# Service-Information

Group: 11 Engine	November 1982	Bulletin No.: 11 019 81 (2031)
---------------------	------------------	-----------------------------------

RE: ENGINE MODIFICATIONS

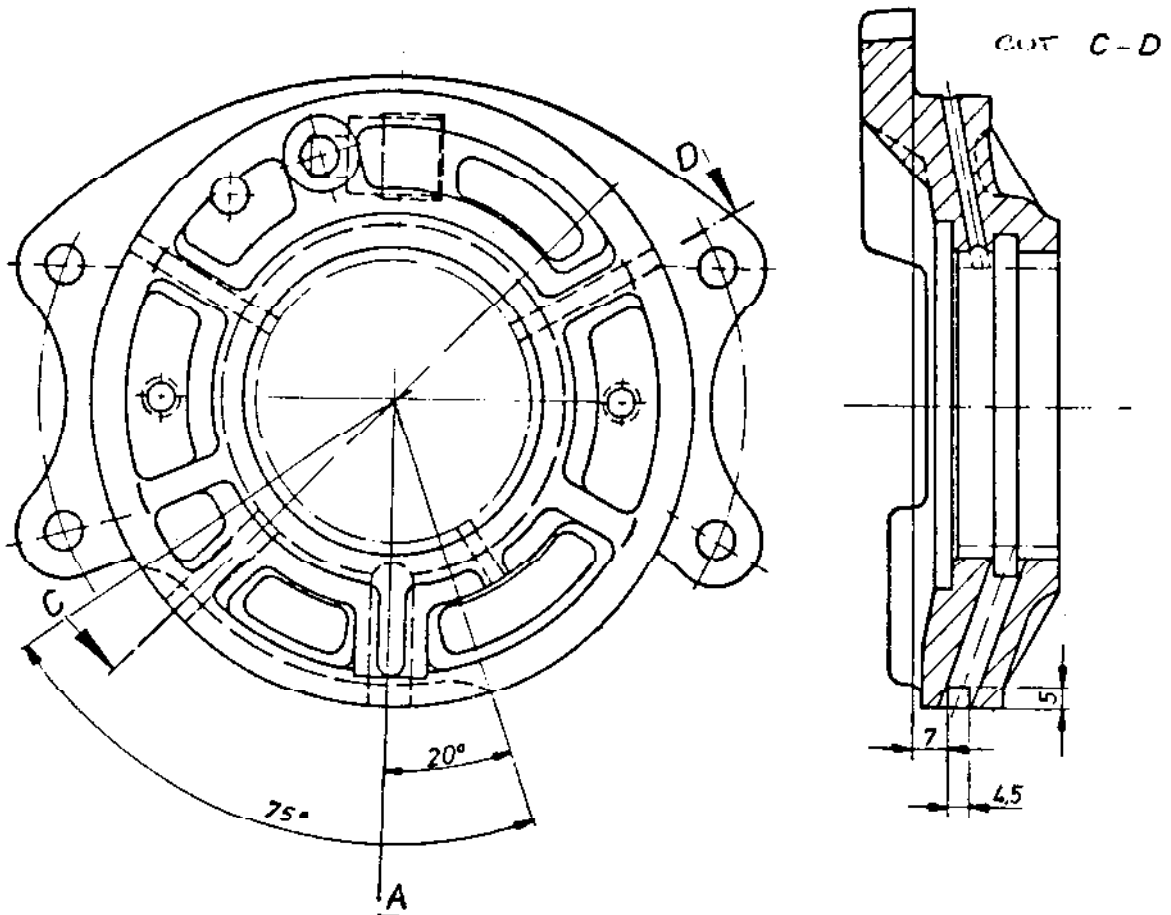
The new crankcases are identified by the trade mark "Alcan" found on the clutch side of the crankcase as a cast mark.

When an "Alcan" crankcase is used as a replacement on models which utilize a duplex (double row) timing chain camshaft drive (models 1970 to 1978), you must do one of two things:

- (1) replace the front main bearing holder with a new design, part No. 11 11 1 259 593,
- (2) modify the existing main bearing holder to provide an oil distribution passage on the outer edge.

If you choose to modify the main bearing holder rather than replace it, use drawing below:

If the above-mentioned modification or exchange is not done, no oil pressure will be obtained.
